Village of Arlington Heights
Plat and Subdivision Committee
Community Room, 3rd Floor
Arlington Heights Village Hall
33 S. Arlington Heights Road
Arlington Heights, IL 60005
January 28, 2015
6:30 PM

Item: South Campus & New Connections Academy - 3333 N. Kennicott Ave. - T1489

STAFF DEVELOPMENT COMMITTEE REPORT

Item: Northwest Metalcraft - 413 S. Arlington Heights Rd. - T1493

PROPOSED
ELEVATIONS

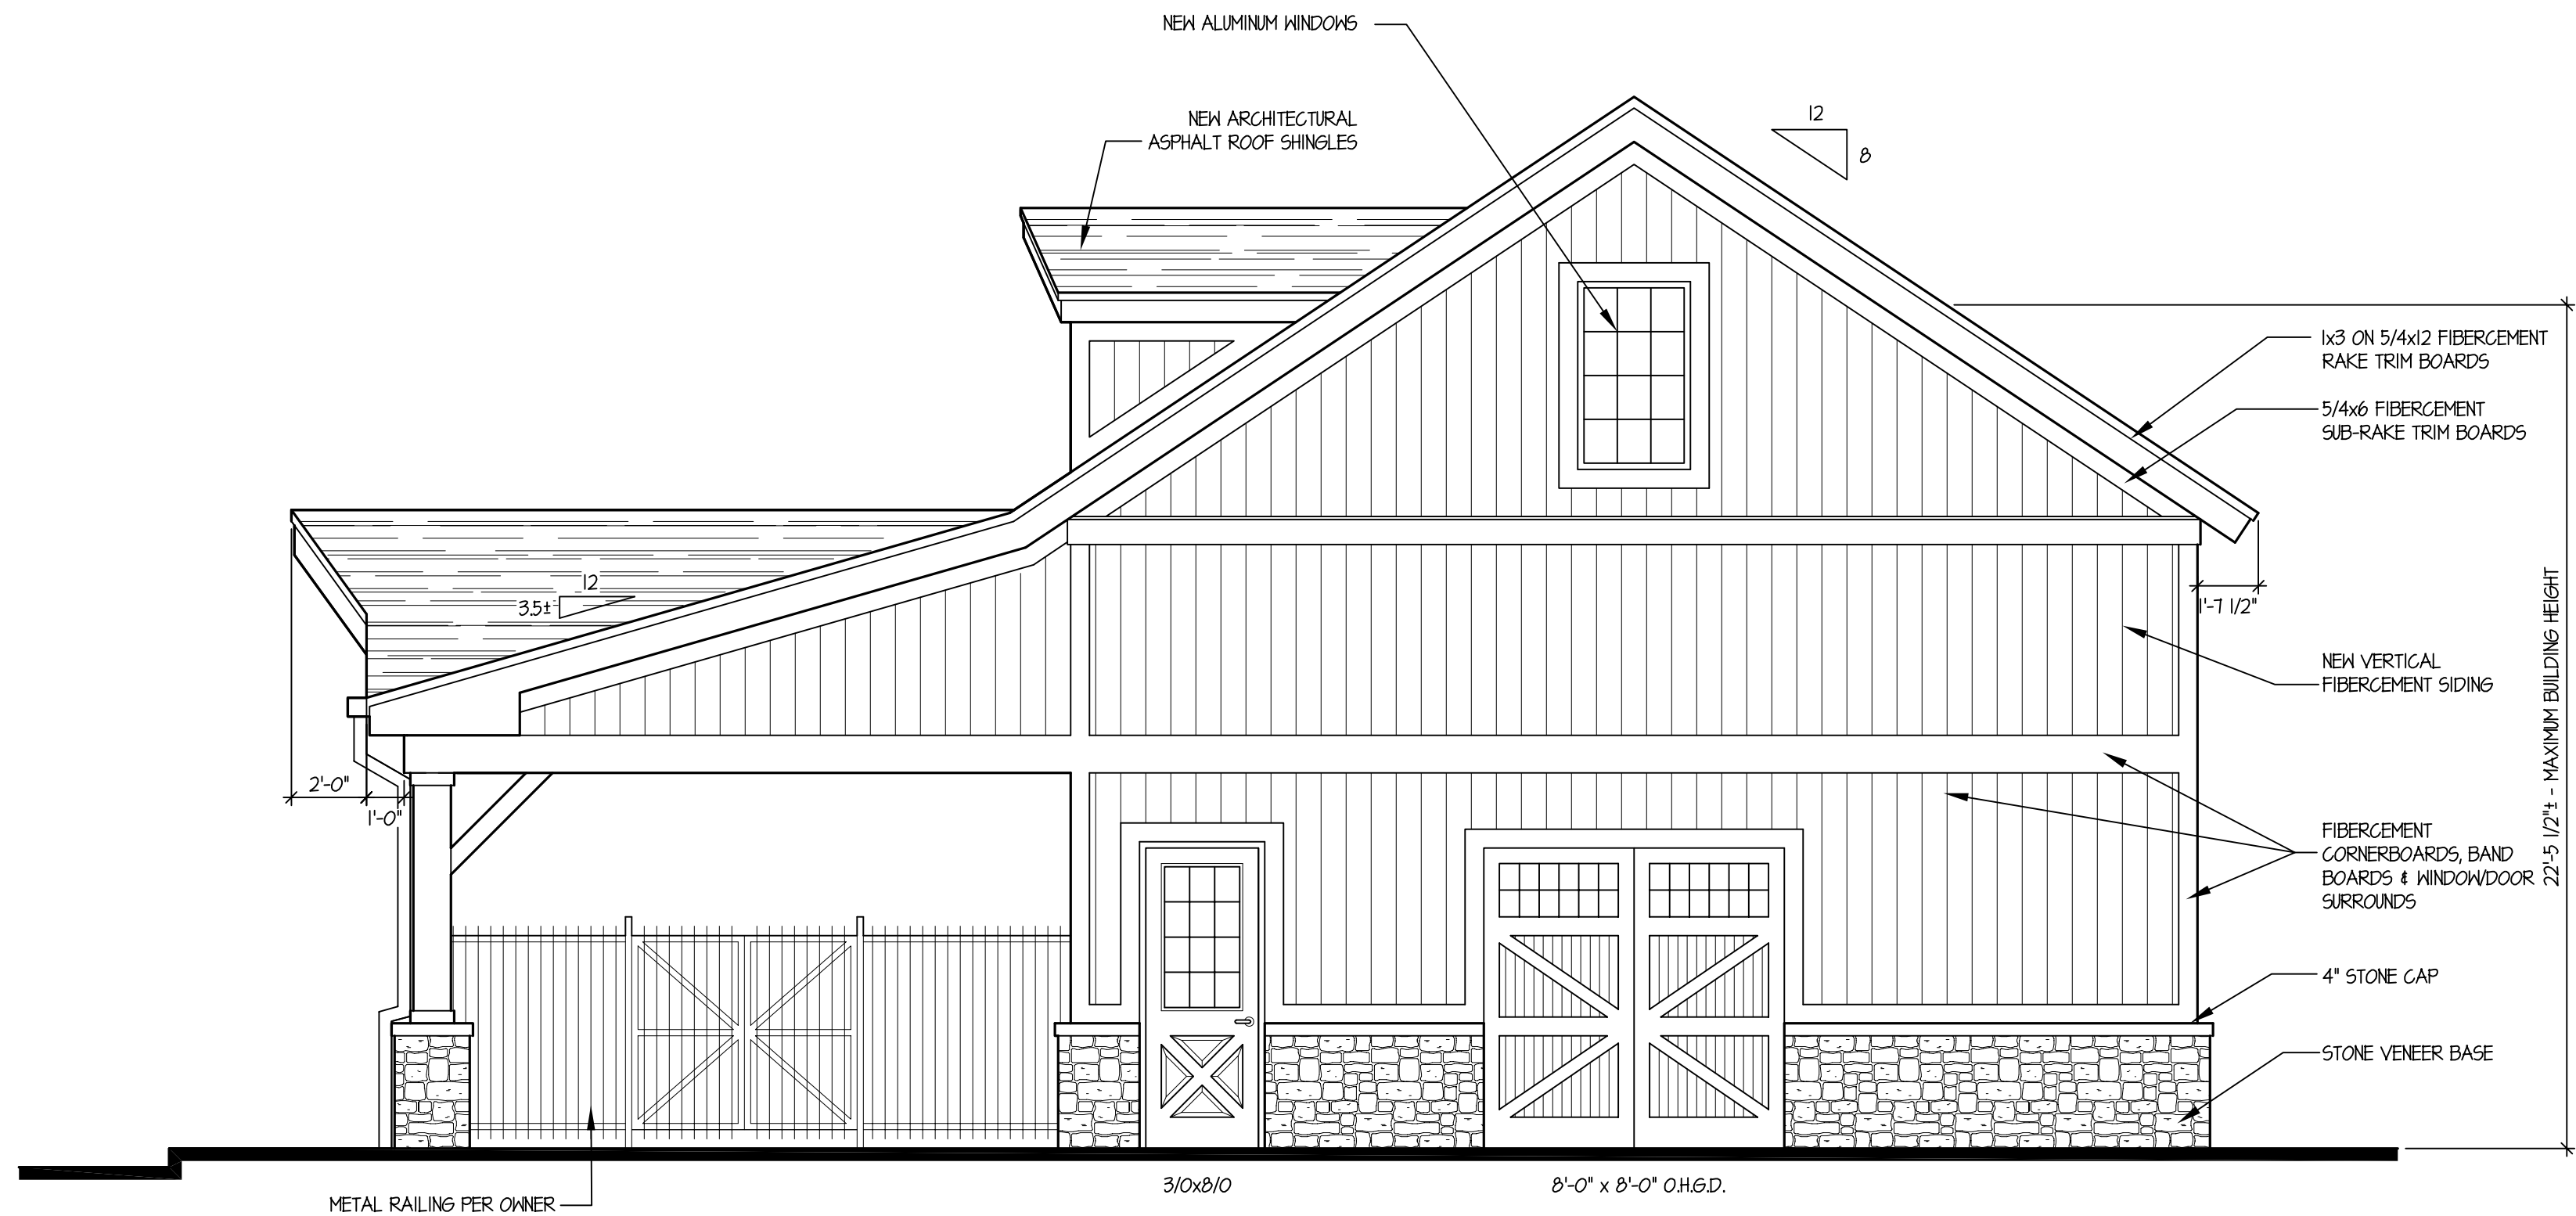
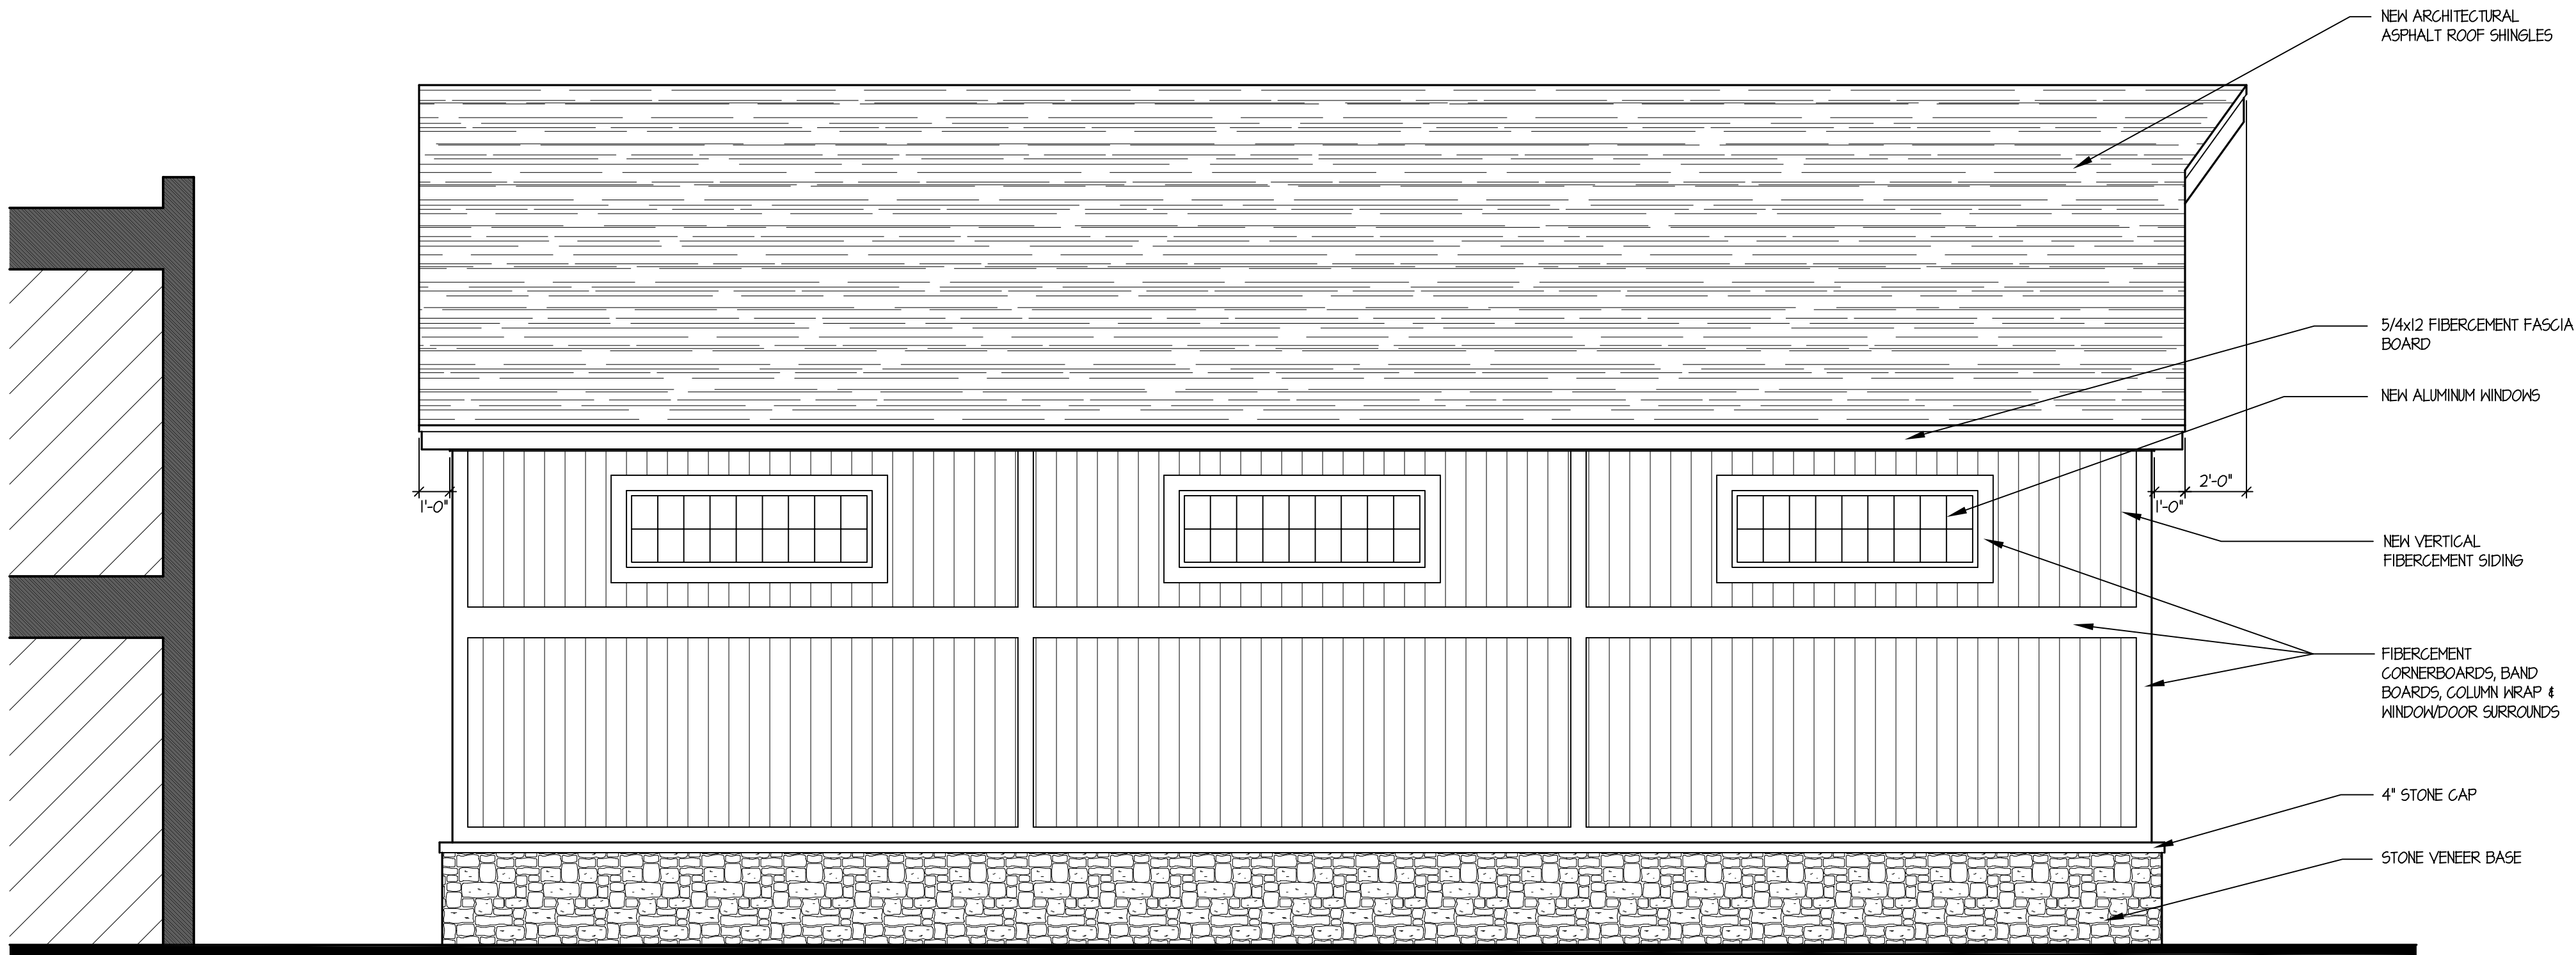
Per Chapter 28, Section 6.15-2.1, where a rear lot line or side line of a property in a Business District coincides with a side or rear lot line of property in adjacent residential districts, screening along such lot line must be provided. The screening can be a well maintained masonry wall; as defined as brickwork or stonework, a solid wood fence; an offset double row of densely planted landscape material or a landscape berm. The plans indicate both a fence and a row of shrubs along the south property line. The Design Commission recommended that the eight Euonymus shrubs along the south property line and the Euonymus shrubs along the east property line be changed to Juniper. The Design Commission also recommended that landscaping be added on the south side of the storage building. Please provide details for the proposed fence.

6. The Euonymus shrubs along the south and east property line must be changed to Juniper.
7. Landscaping should be added on the south side of the storage building.

E1 Planting Layout Plan
SCALE: 1" = 10'

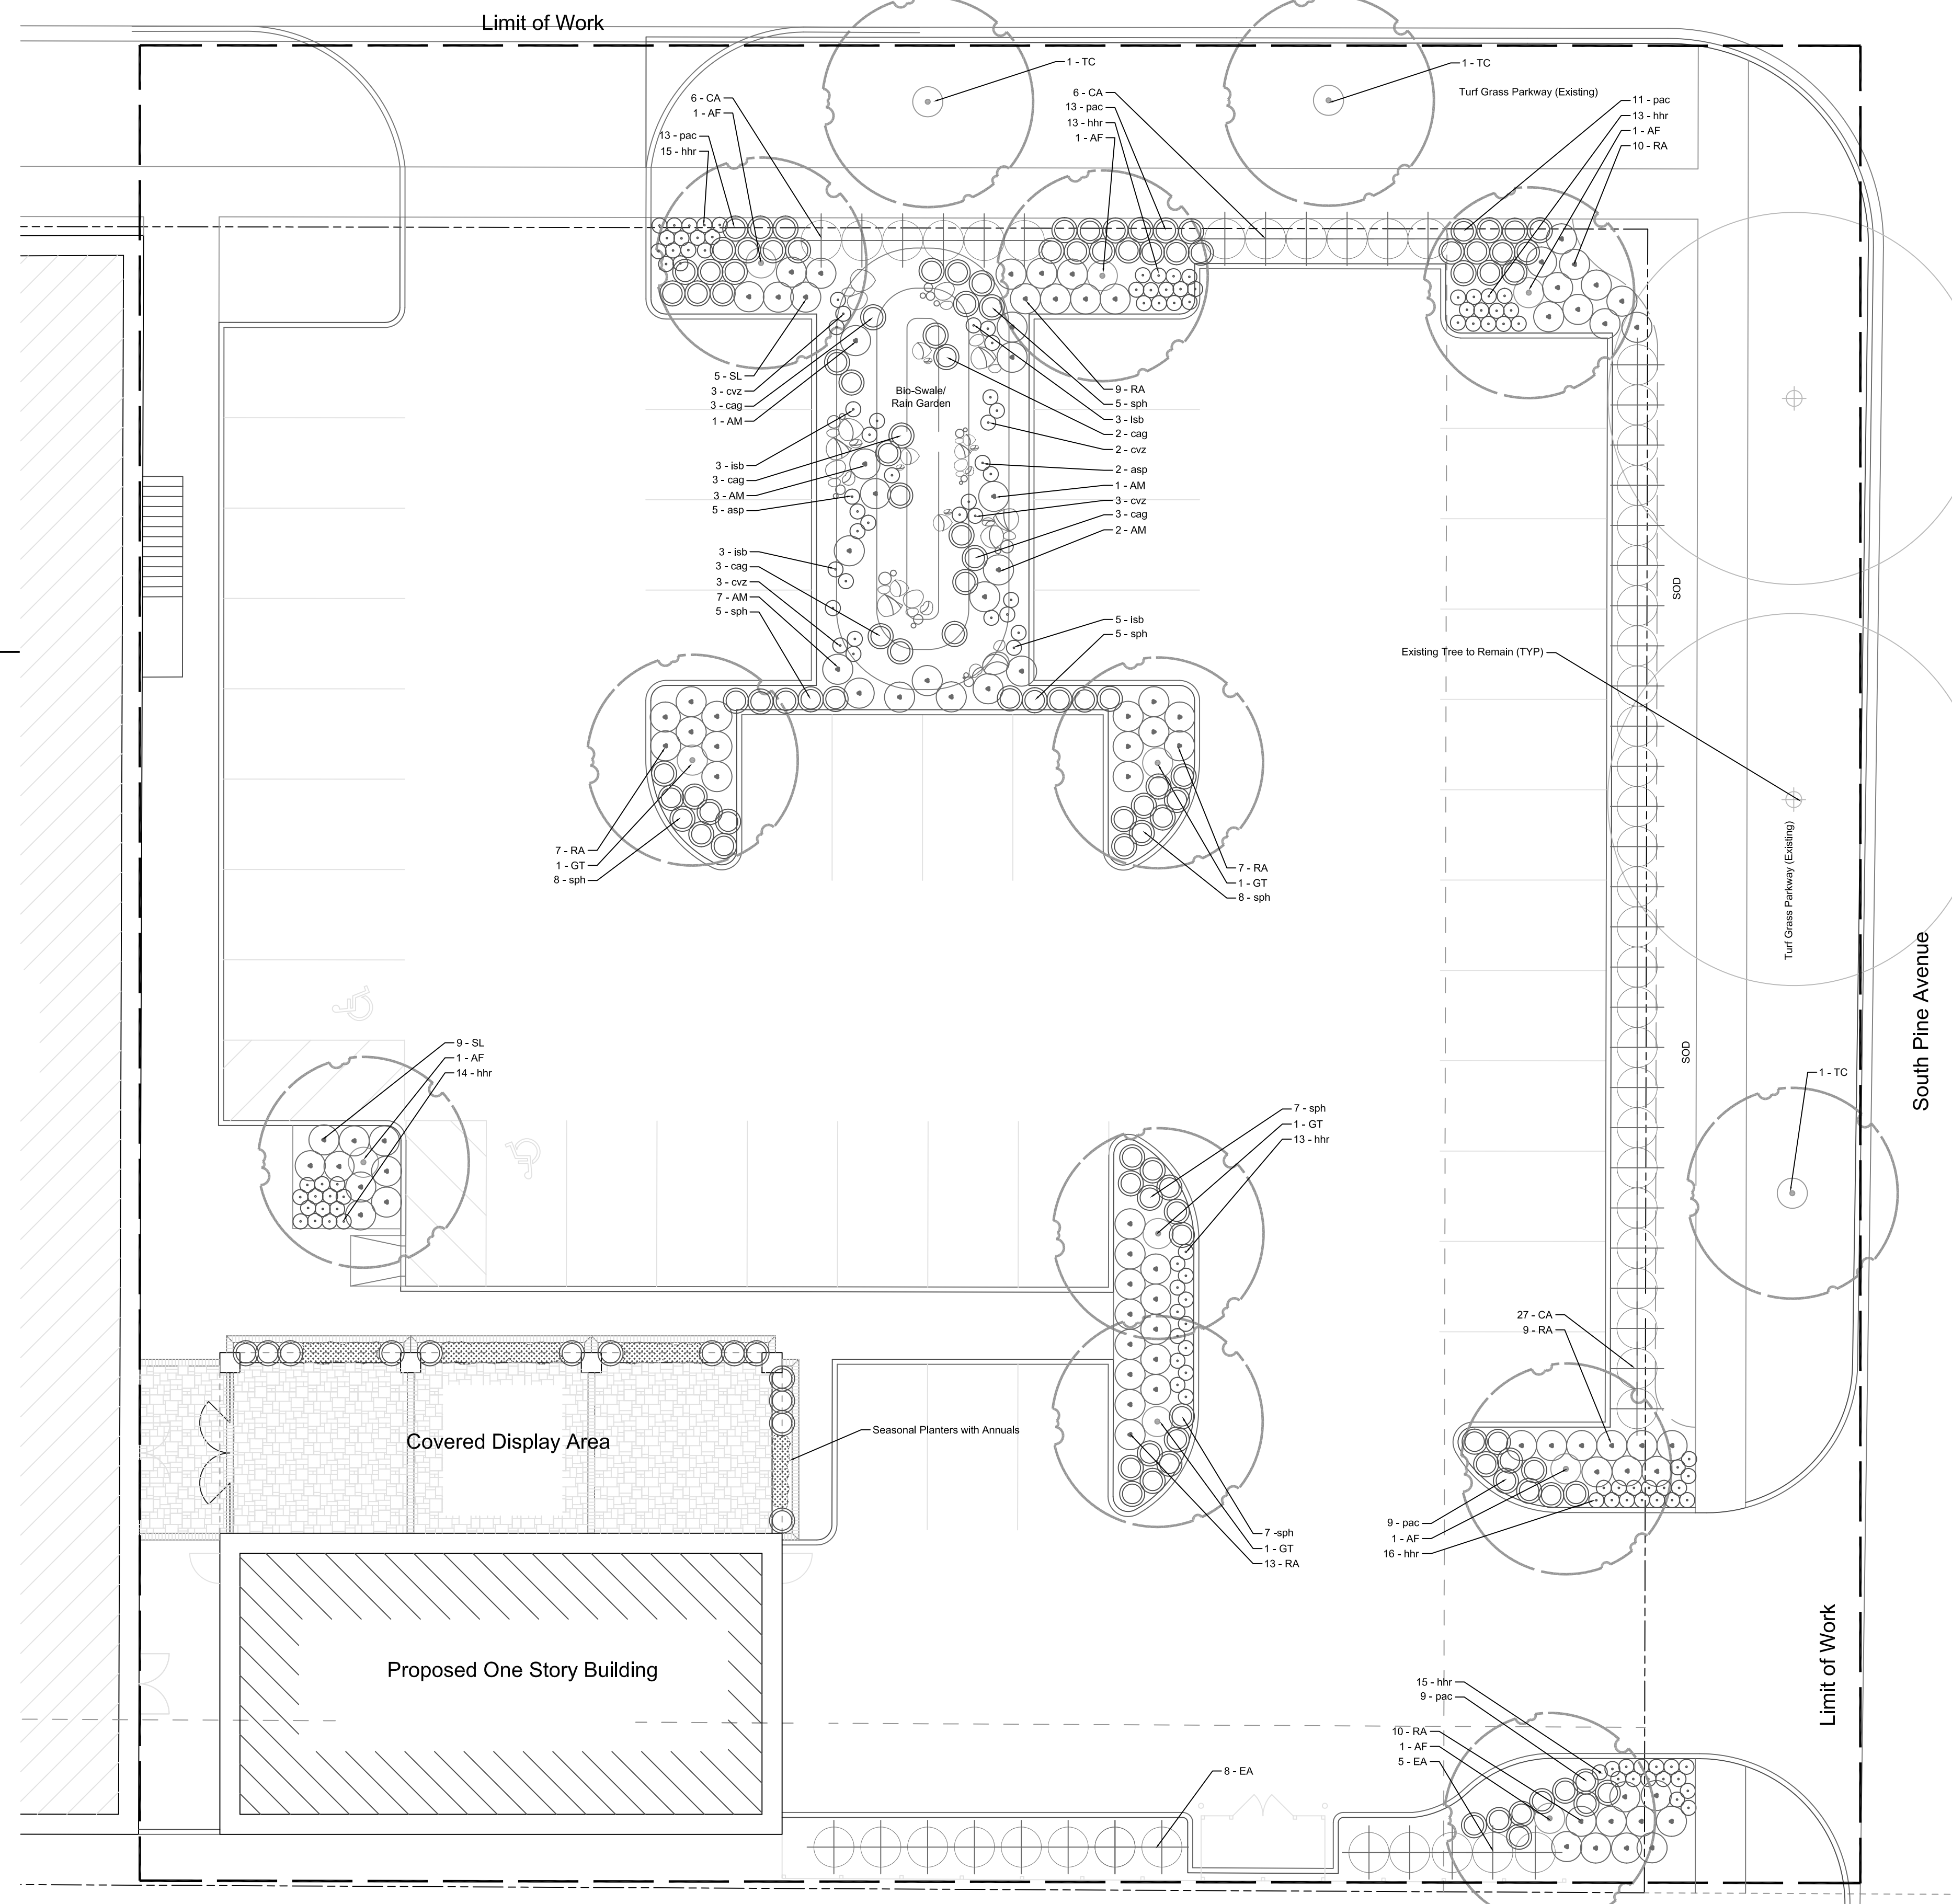
4. The Petitioner will be required to comply with all landscape requirements as part of the Plan Commission approval process or seek a variation. The shade trees at the ends of all parking rows must be required to be increased to four inch caliper and an additional tree must be provided in the northwest island where there is no tree at the end of the parking row.
